LIST OF STANDARD DRAWINGS APPLICABLE FOR 245 KV CT- METERING

CUSTOMER : APTRANSCO		
4				GEN. TOL.	MATL.: SPEC.:	TITLE : LIST OF STANDARD DRGS. / DOCUMENTS APPLICABLE (FOR 245 KV CT- METERING) (200/1 A)
3				THIRD ANGLE PROJECTION		
				SCALE: NTS	INITIALS	NAME
2				ALL DIMNS. IN MM. UNLESS OTHERWISE SPECIFIED.	ORG	NSB
					CHD	SHB
1					APPD	USS
						DRG.NO: 3-KAD 5386
						REV 0
NO	REVISION	SIGN	DATE	DATE : 09.06.2021

CUSTOMER : APTRANSCO				GEN. TOL.		MATL.: SPEC.:		TITLE : GENERAL ARRANGEMENT (FOR 245 kV CT- METERING) (200/1 A)	
THIRD ANGLE PROJECTION				SCALE: NTS		INITIALS		NAME	
3 2 1 NO REVISION SIGN DATE				ALL DIMS. IN MM. UNLESS OTHERWISE SPECIFIED.		DRN		NSB	
						CHD		SHB	
						APPD		USS	
DATE : 09.06.2021				CG Power and Industrial Solutions Limited S1 - DIVISION, AMBAD, NASHIK		DRG.NO: 3-KAD 5387		REV 0

RATING AND SCHEMATIC PLATE

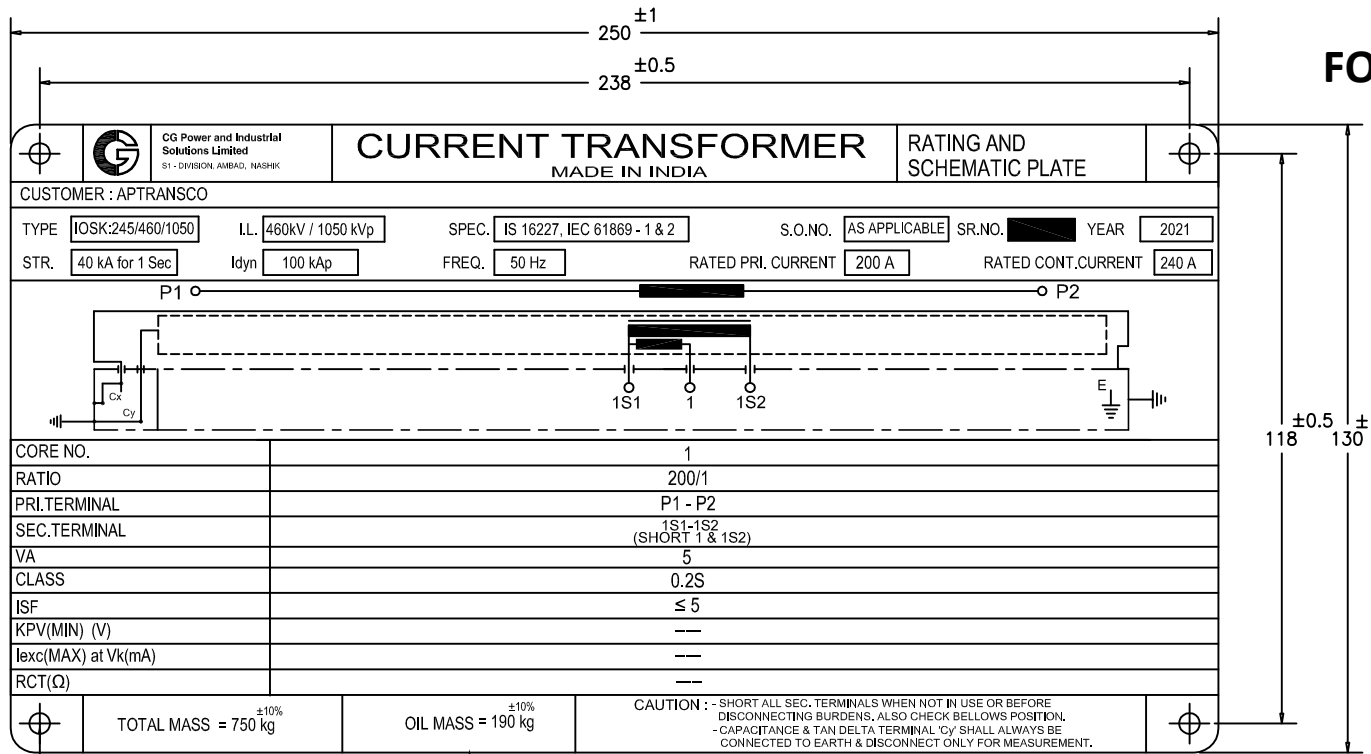
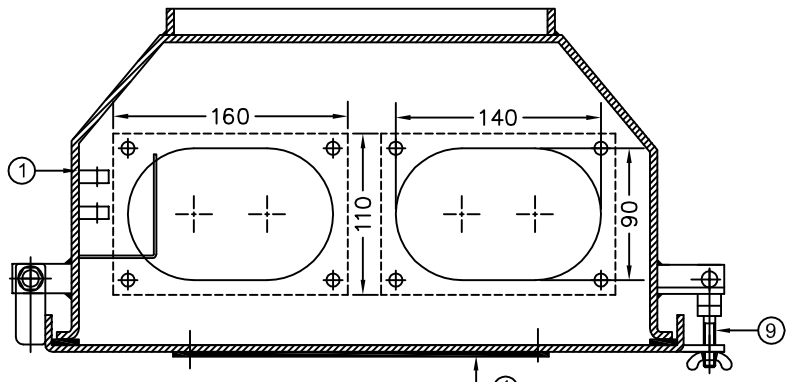
NOTE : DRAWING APPROVAL SUBJECT TO VALID TYPE TEST REPORTS, TO BE CHECKED DURING ACCEPTANCE TESTS.

- 1). Minimum 300 mm Plinth shall be maintained for Current transformers in the substation during foundation works to ensure safe live to ground clearances as per IE rules.
- 2). Since the supply of terminal connectors is not in the scope of CT Manufacturer as mentioned in the drawings, the EPC contractors shall be instructed to supply the same in line with the CT requirement and compatibility.
